# County of Fairfax, Virginia

## **STAFF REPORT**

### **APPLICATION RZ 2013-LE-013**

**PROPOSAL:** To demolish the two existing dwellings and rezone from R-1 to R-8 to permit the construction of 14 single family attached dwelling units

**Figure 4:** The half-circle represents the 257 square feet reserved for public street purposes, while the polygon is the 687 square foot dedication (Source: Charles P. Johnson & Associates, Inc., 12/6/2013)

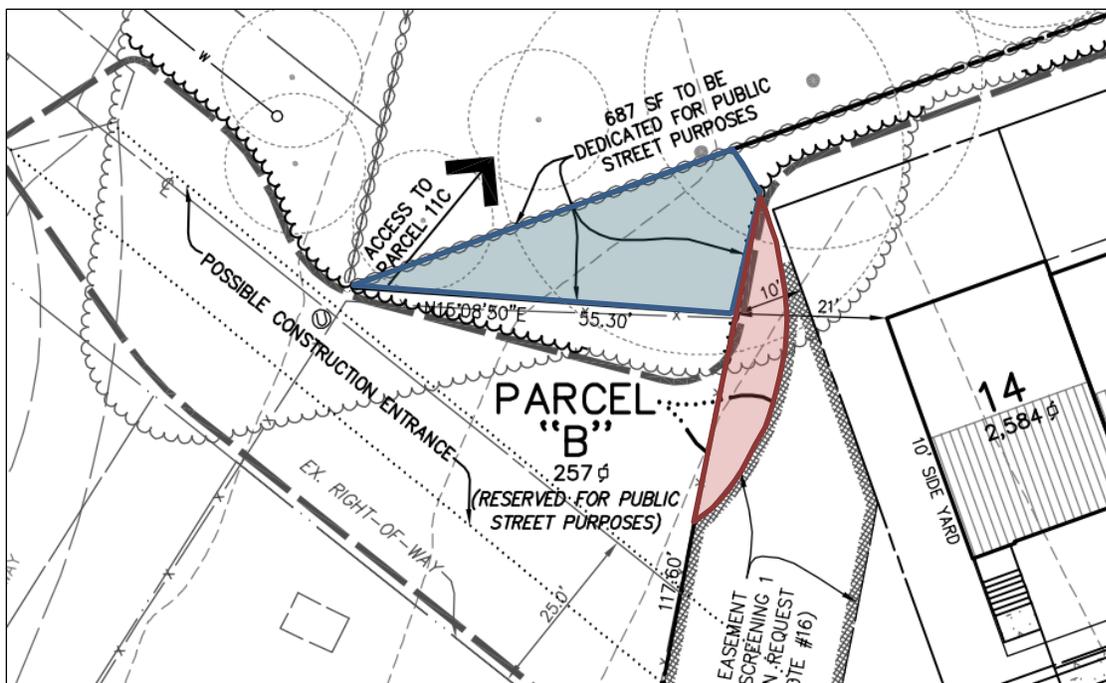
The GDP indicates Barbara Road may be used as the construction entrance for contractor vehicle traffic if the rezoning is approved. The applicant may need to reconstruct Barbara Road's terminus with a modified turnaround that meets VDOT and PFM standards if Barbara Road is used as a construction entrance. The applicant identified 687 square feet of that would be dedicated to the Board of Supervisors for public street purposes, and 257 feet that would be reserved for future dedication (Figure 4). This square footage could be used in the future to provide vehicular access, if deemed necessary, to Parcel 11C. The applicant's dedication and reservation

assumes that a portion of Parcel 11C would need to be used in order to construct a cul-de-sac at the end of Barbara Road to access Parcel 11C.

Proffers 12 and 13 in Appendix 1 further articulate the applicant's commitment to providing the reservation and dedication for a modified turnaround at the end of Barbara Road.

**Figure 5: The proposed fencing along Franconia-Springfield Parkway to reduce noise impacts from traffic (Source: Charles P. Johnson & Associates, Inc., 12/6/2013)**

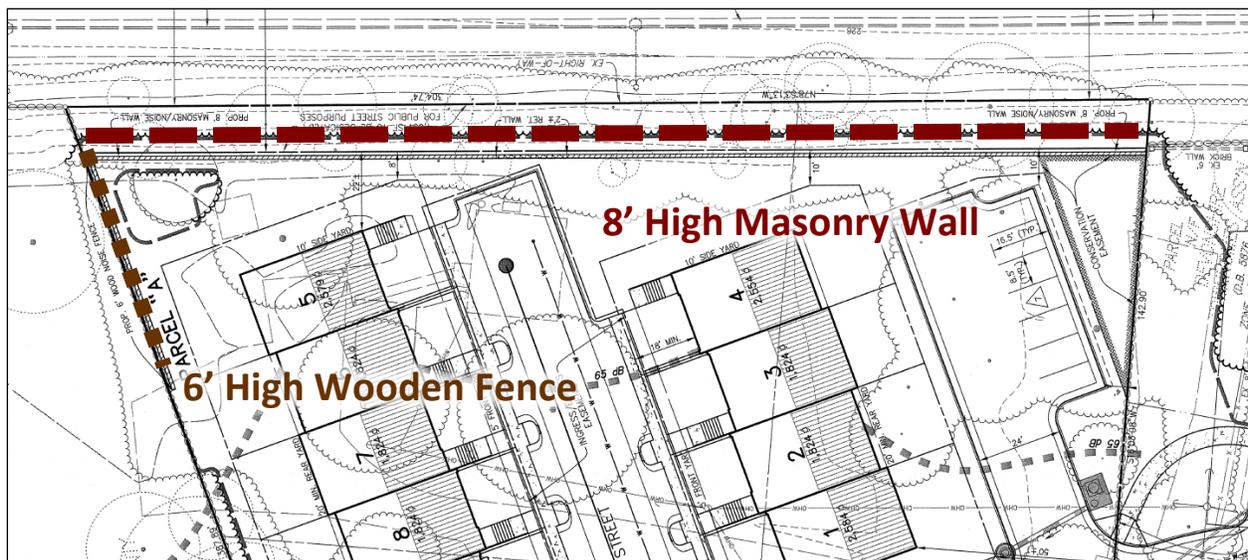
**Noise Attenuation Walls:** Along the subject properties' ultimate boundary with Franconia-Springfield Parkway, the applicant would construct an 8-foot high masonry wall. This wall's primary purpose would be to reduce the impact of noise on the proposed dwellings from vehicular traffic travelling along Franconia-Springfield Parkway. The applicant would supplement this masonry wall with a 6-foot high wooden fence along approximately 80 feet of the western property boundary. This fence would intersect with the 8-foot high masonry wall (Figure 5).

Layout: The proposed layout would provide appropriate relationships between the proposed dwellings and their respective front and rear yards. The proposed masonry wall along Franconia-Springfield Parkway is logically located to provide noise attenuation.

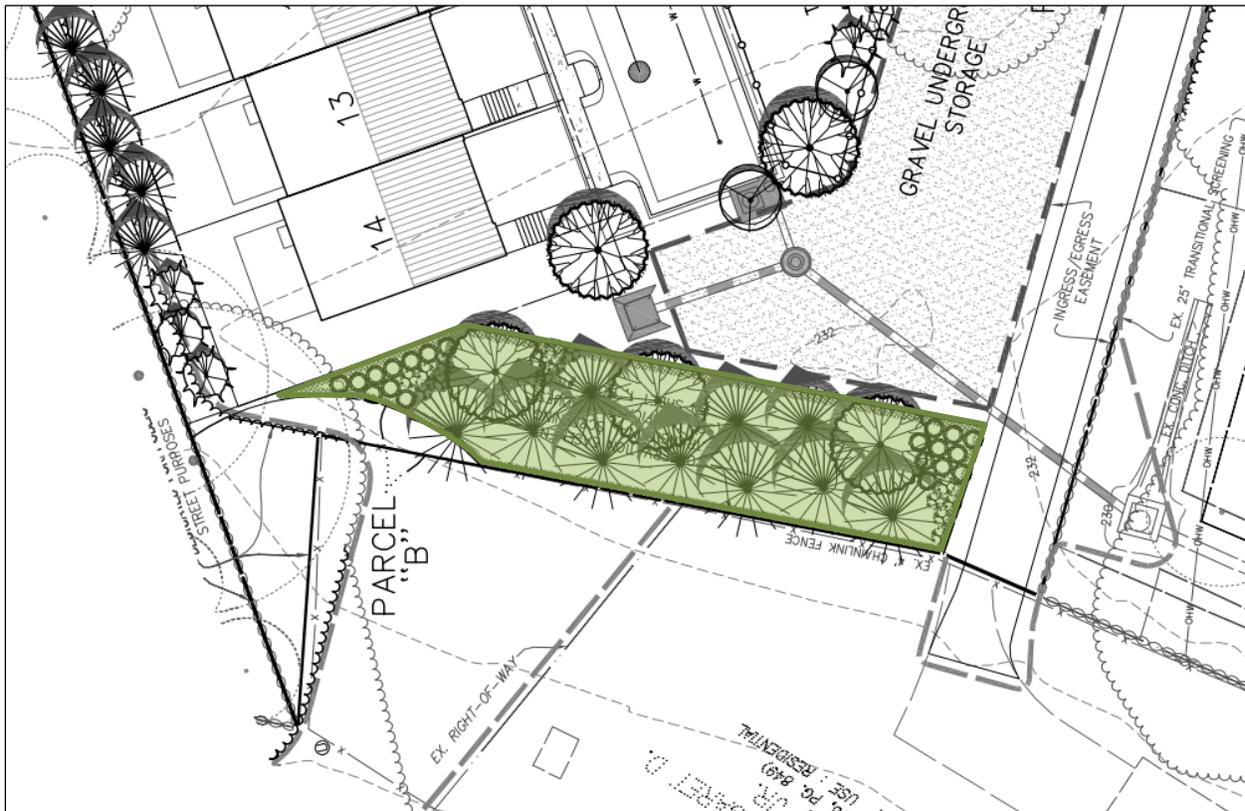
The applicant has provided an approximately 25-foot wide buffer of trees along the properties' southern boundary. However, this buffer tapers at its western end, so the applicant has requested a modification of the transitional screening requirement found in Article 4 of the Zoning Ordinance. Figure 6 depicts this transitional screening. Staff will discuss the applicant's request for a modification in the Modifications and Waivers section of this staff report.
